IC RETE GPU & IC RETE DPEIR EH Feb. 24, 2015 final 25 of 26

# Response to Comment Letter #20: Edie Harmon

## COMMENTS ON THE DRAFT PROGRAM ENVIRONMENTAL IMPACT REPORT (PEIR) FOR RENEWABLE ENERGY AND TRANSMISSION ELEMENT (RETE) (SCH #2014071062)

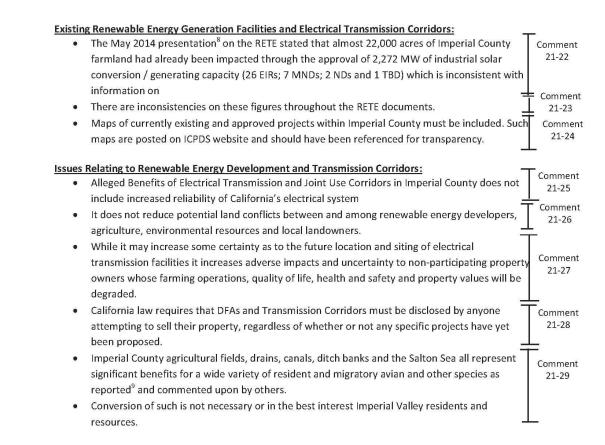
- Figure 2: Potential Wind Power Resource Areas does demonstrate the generally poor and Comment limited wind resources located in the County but FAILS to include any disclaimers or boundaries 21-35 of wind resource areas, most of which are located within the Jacumba Wilderness Area, and other protected lands. Comment

- Figure 4 Existing and Proposed Energy Transmission System: Fails to include the 1-2 new 500kV lines proposed for various DRECP alternatives between Imperial Valley and San Diego, basically Comment in the same areas impacted by SDG&E's existing 500kV Sunrise Powerlink and 500kV Southwest 21-37 Powerlink, as documented by the DRECP's Transmission Appendix K. In December 2014, SDG&E announced that their Sunrise Powerlink has reached 1,000 MW<sup>10</sup>, and that seven of the ten Imperial Valley solar projects they had contracted with were now delivering that energy. Therefore, Sunrise Powerlink should not be counted on for additional capacity.

- Figure 2.4-1 Overlay Zone Map shows 267,141 acres included in energy overlay zones, including Comment farm land, adjacent to communities (difficult to determine how close due to lack of town 21-38 locations), undisturbed desert lands (including part of the withdrawn Sterling Imperial Valley Solar project footprint near Plaster City), and impacting the Salton Sea and other sensitive lands and resources. Comment

- Figure 2.4-2 Fails to include the real potential for one or two new 500kV lines from SDG&E's Imperial Valley Substation to San Diego as disclosed in the DRECP Appendix K
